**Board of Adjustment
Special Meeting Agenda
Fraser Town Hall, 153 Fraser Avenue
Wednesday February 26, 2025
5:30 PM - 6:30 PM**

a. Appeal Of Administrative Variance Denial - The Ascent

Project Name: The Ascent – Final Plat, Site Plan, and Administrative Variance

RE: The Ascent – Final Plat, Major Site Plan, Administrative Variance
Planning Review Comments (1st Referral Review)

SITE PLAN
January 29, 2025
SHEET 2

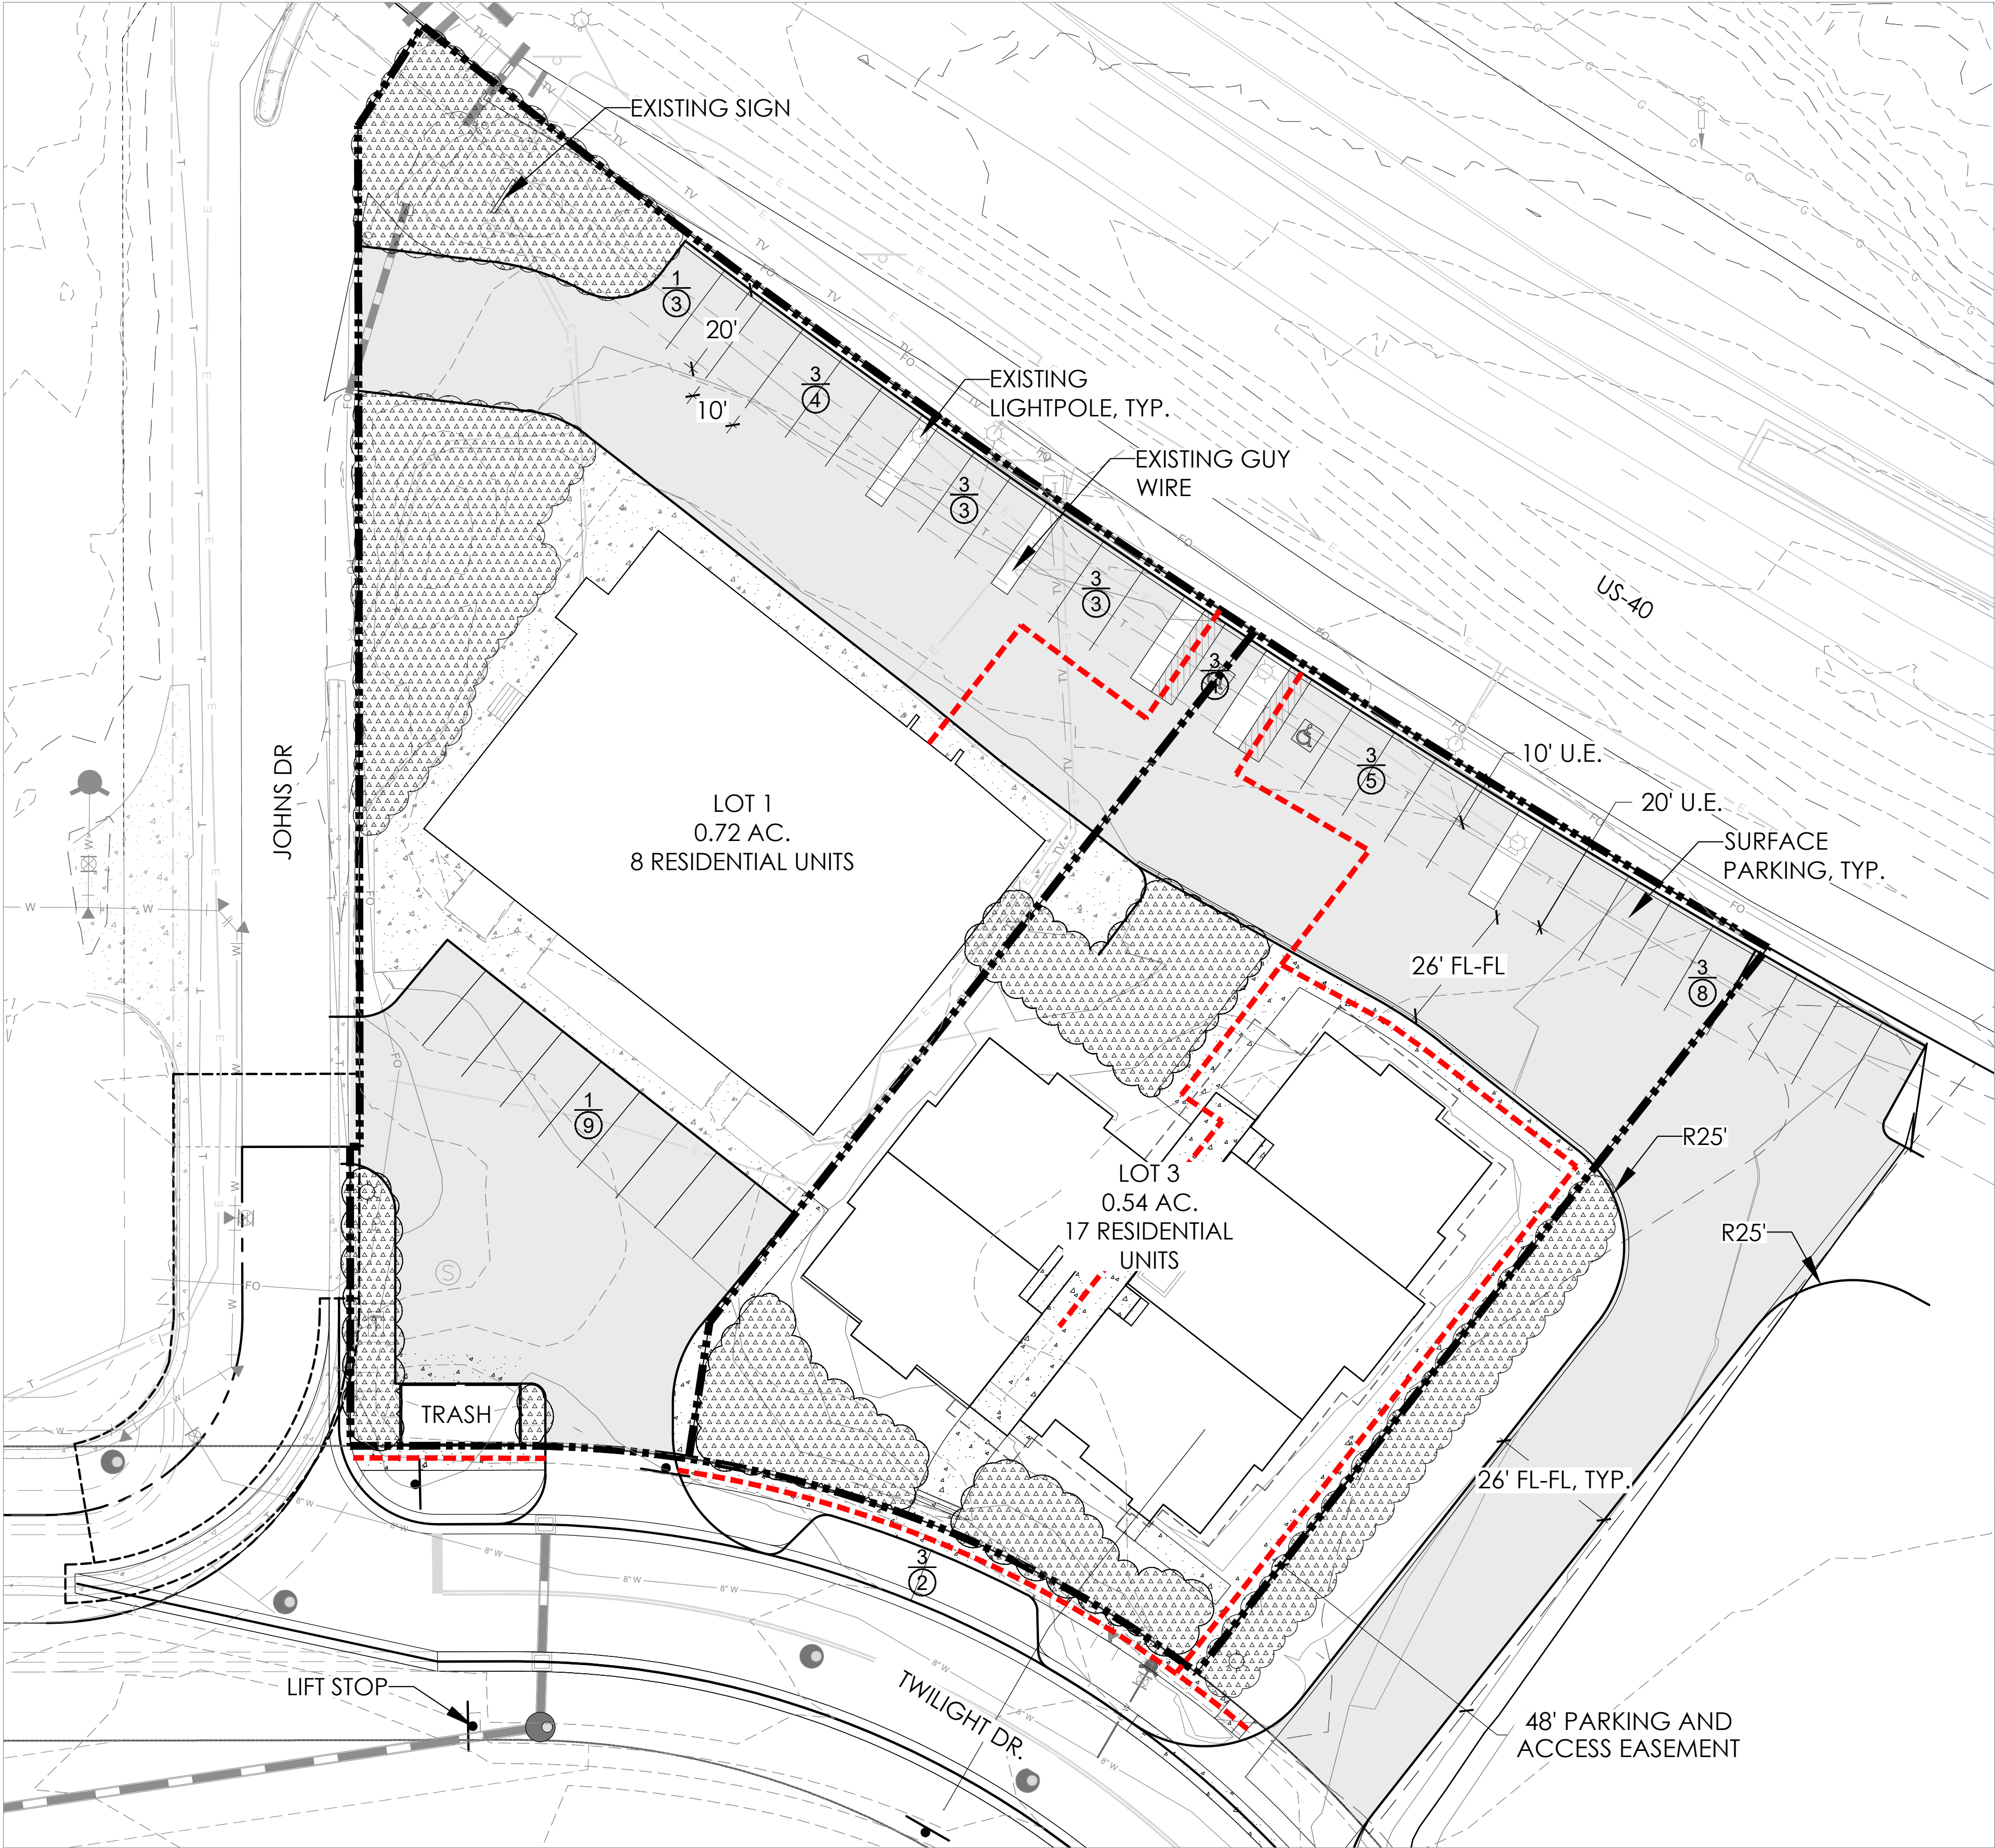
Sheet 2 – Site Plan

- 24) Provide a trash enclosure detail showing conformance with [Sec. 19-4-160\(b\)](#), i.e., label the enclosure color and materials to ensure they are consistent with those of the main building.

- 25) Include a summary of unit types by bedroom count or note that all units will be two-bedroom units.
- 26) Note or provide in the data table the number of bedrooms in the existing two units in the XSports building since there will be shared parking between the lots.

- 28) Please add a note that the two parallel spaces proposed along “Victory Rd” within the proposed ROW are included in the provided parking count.
- 29) Data table lists Lot 1A and 2B. Should be 1A and 1B unless the lots are renumbered to Lot 1 and Lot 3 as requested by staff.

- 30) Please remove floor plan linework from building footprints for clarity.
- 31) In September 2024, the Town adopted by reference the 2023 Colorado Model Electric Ready and Solar Ready Code. The site plan must display compliance with applicable requirements of this code before building permits are issued. Please designate on the parking plan at least a minimum number of EV spaces per the requirements below. Definitions for each category of EV capability are found in Chapter 2 of the referenced code. Multifamily residential is found on page 25 and must include the following:

LANDSCAPE PLAN

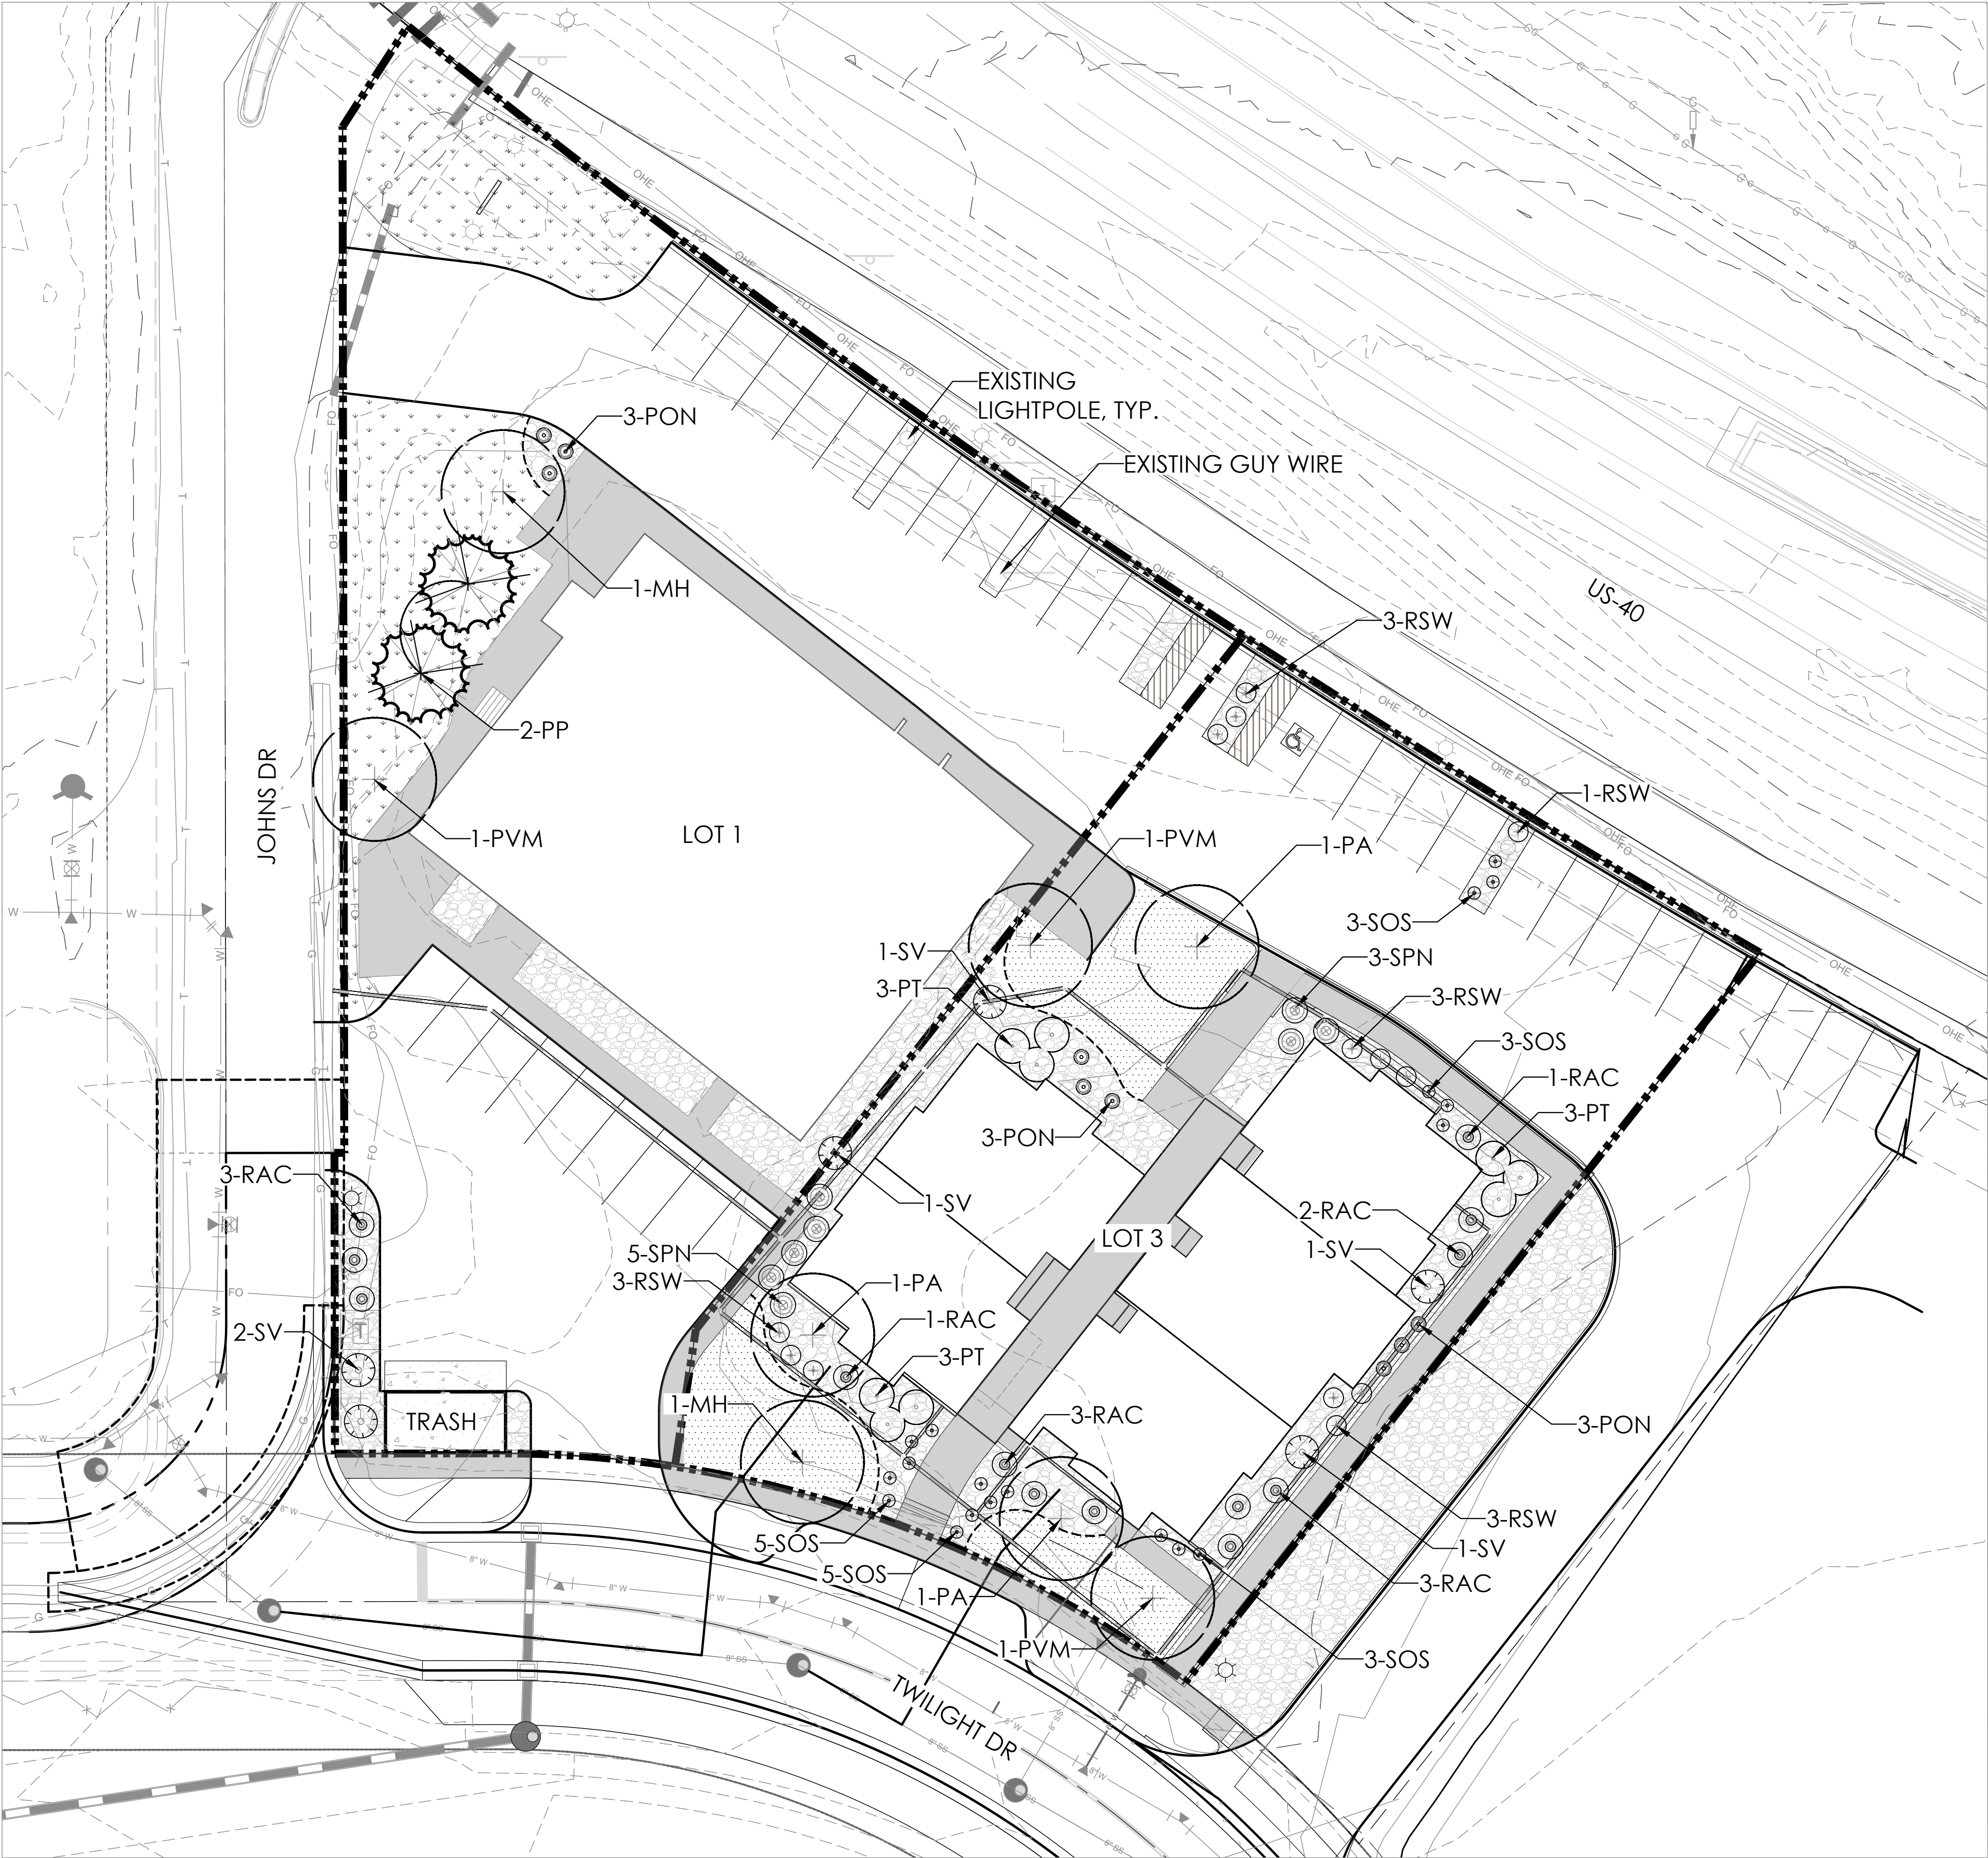
Sheet 3 – Landscape Plan

- 34) [Sec. 14-5-40\(10\)](#) requires parking lot interior landscaping islands for parking lots with twenty (20) or more parking spaces at a ratio of one hundred (100) square feet and one (1) tree and two (2) shrubs for every ten (10) parking spaces. Please provide additional interior landscaped islands within the parking area on the northeast side of the site, similar to the two that are proposed at either end of the southeast row of parking.

- 35) Provide the following as required in [Sec. 14-5-40](#) - landscaping specifications:
- Provide an irrigation plan, if irrigation is to be provided.

- Include a statement providing that the owner and his or her heirs, successors and assigns will provide adequate maintenance for all site elements. Landscaping maintenance shall include irrigation, fertilization, pruning and noxious weed control.

- Include contact information on who prepared the landscape design. A landscape plan drawn by a landscape architect or designer is preferred but is not required.

- 36) Please provide a cost estimate of the proposed landscaping subject to the following requirement from [Sec. 14-5-40\(11\)](#). This amount will need to be included in the collateral collected as part of the DIA:
